Title		
EFM POWER		
Size	Document Number	Rev
B	<Doc>	<RevCode>
Date:	Sunday, September 01, 2013	Sheet 6 of 10

Title		
<Title>		
Size	Document Number	Rev
B	<Doc>	<Rev Code>
Date:	Sunday, September 01, 2013	Sheet 5 of 10

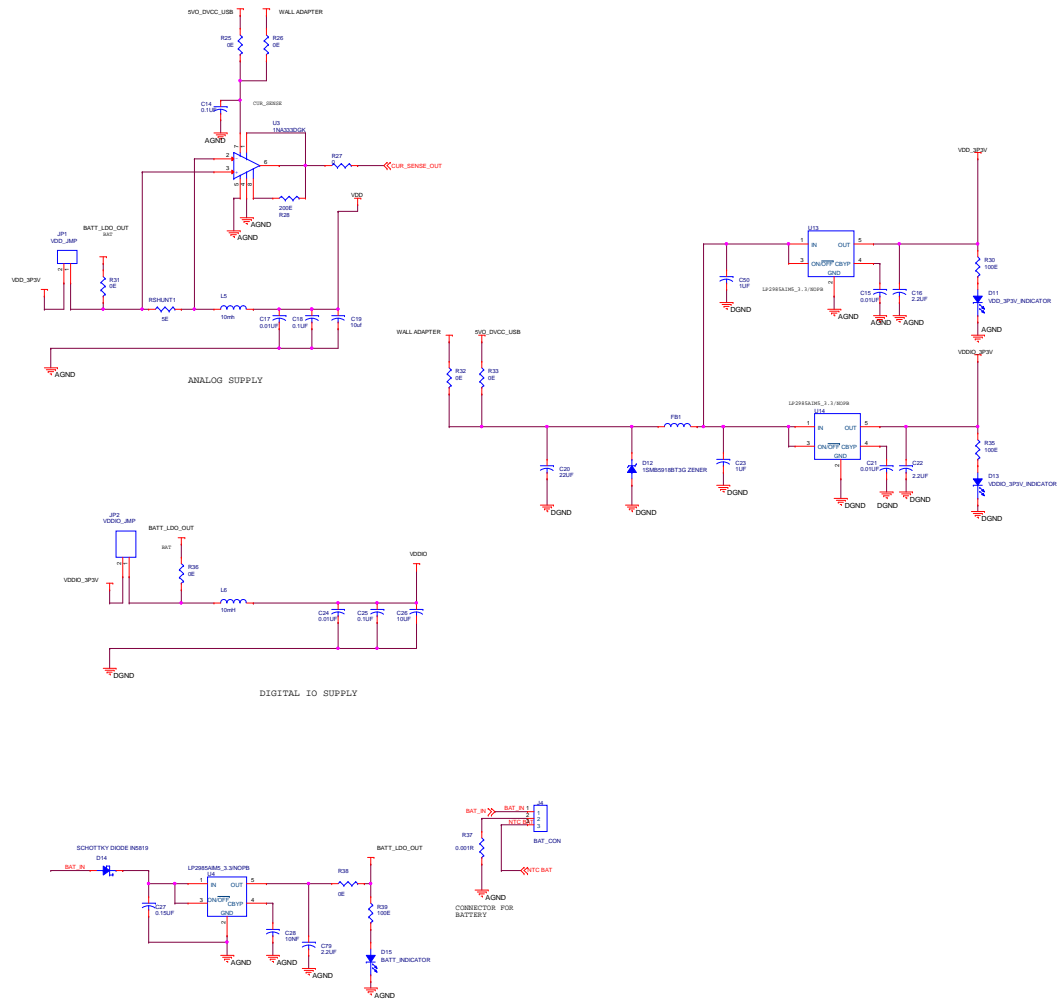
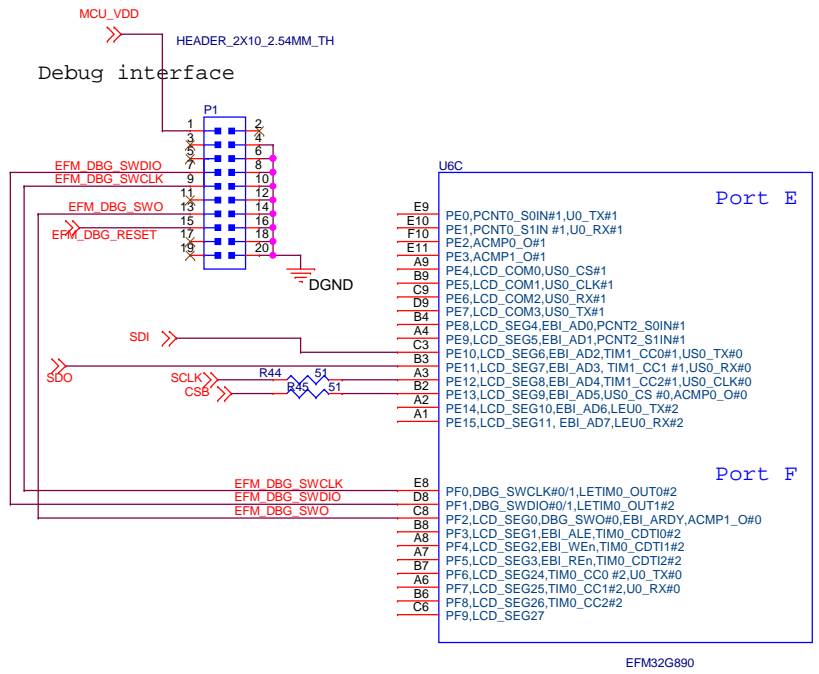
SWING VOLTAGE OF ACCEL IS 2.55V

R22 ,R23, R24 are deleted from this page.

Layout consideration: This regulator should be placed near to LTC3558

leds are deleted from PORTF and PORTE

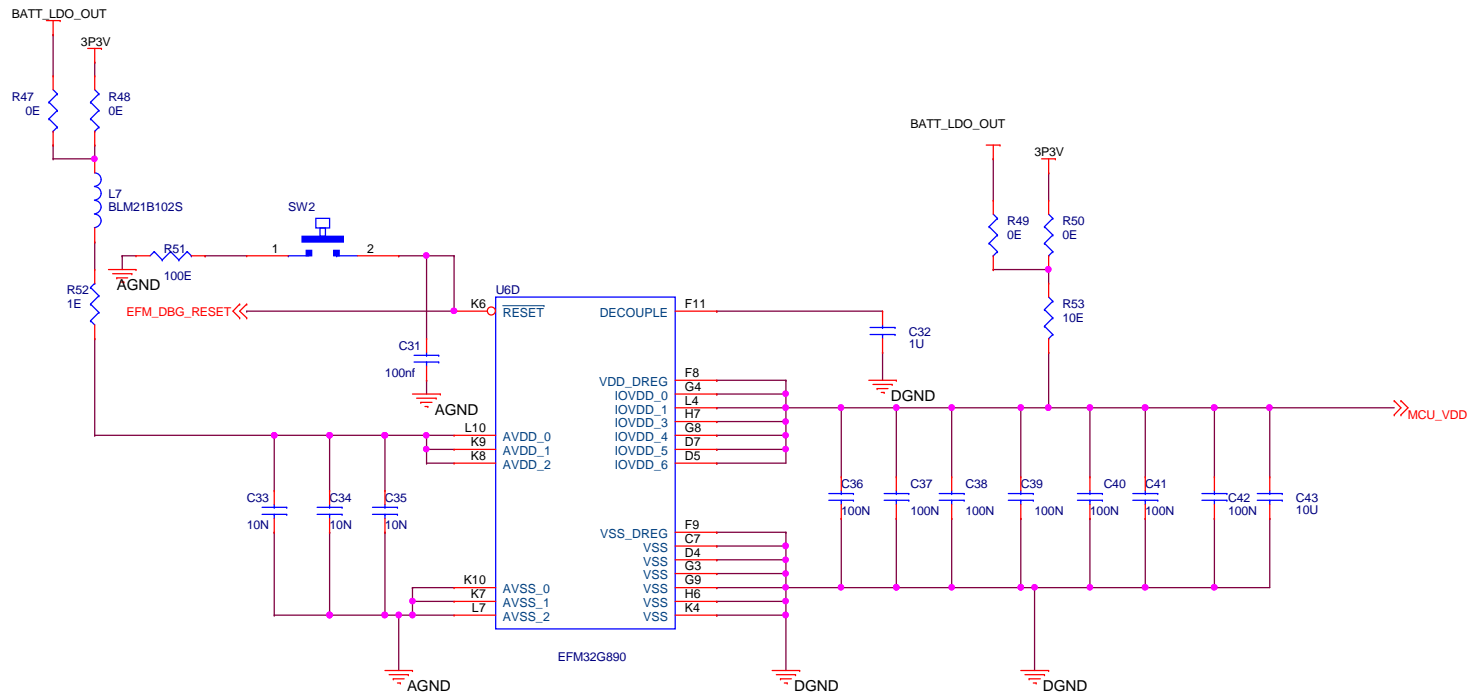
All above 100nf capacitors package is changed from0603 to 0402
